Determination 2014/057

Dispute about provision of an accessible reception counter to a Corrections facility at 20 Johnston Street, Greymouth

Figure 1: Section through new reception counter (not to scale)

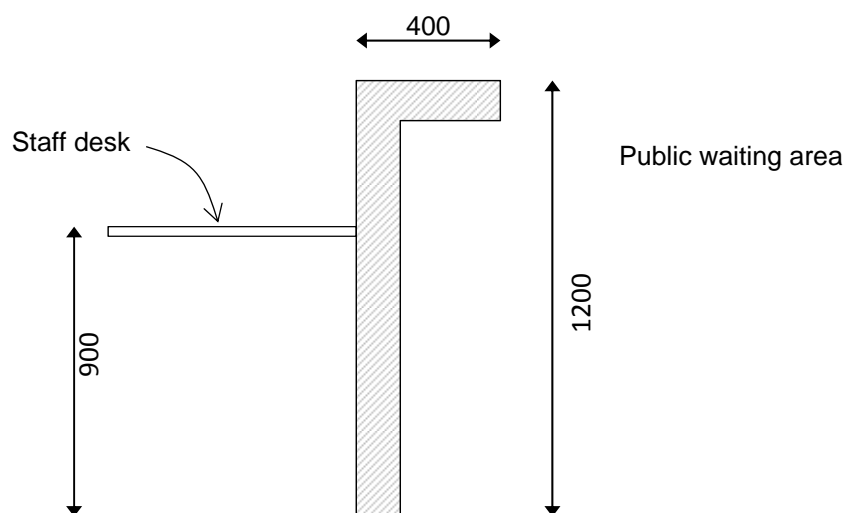
5.4.4 I am of the view that the reception counter at 1200mm high as built does not comply with the requirements of the Building Code. The counter would be restrictive in terms of a disabled person’s ability to see or be seen, and to reach items if required. I note that the range of disabilities to be considered in terms of accessibility of reception counters are broader than just those who use wheelchairs; NZS 4121 provides various examples of disabilities such as extremes of physical size and reaching disabilities.

... a counter [1200mm] high can become a separation barrier for many other people and for wheelchair users. Often a high counter is used to provide security or privacy for staff, but it is always possible to provide a good design solution that meets everyone’s needs.

5.4.6 In addition the commentary to paragraph 11.1.3 of NZS 4121 states ‘where security is a requirement, consideration should be given to the innovative use of step-down counters, security grilles or toughened glass’.

- 5.4.10 I accept the applicant's comment that the facility in this case, unlike the bank in Determination 2004/65, does not require transactions over the reception counter, and that the interview rooms will be used by every visitor attending the facility. However, the purpose of the reception counter is still to register visitor arrivals, which requires that a person is able to see and easily attract the attention of a member of staff, and equally be seen by them.

- 6.4 In order to bring the building work into compliance with the Building Code and ultimately that a code compliance certificate may be issued, it is now for the applicant to apply for an amendment to the consent for a compliant reception counter.

- 7.1 In accordance with section 188 of the Building Act 2004, I hereby determine that the reception counter does not comply with Clause G5.3.4 of the Building Code.
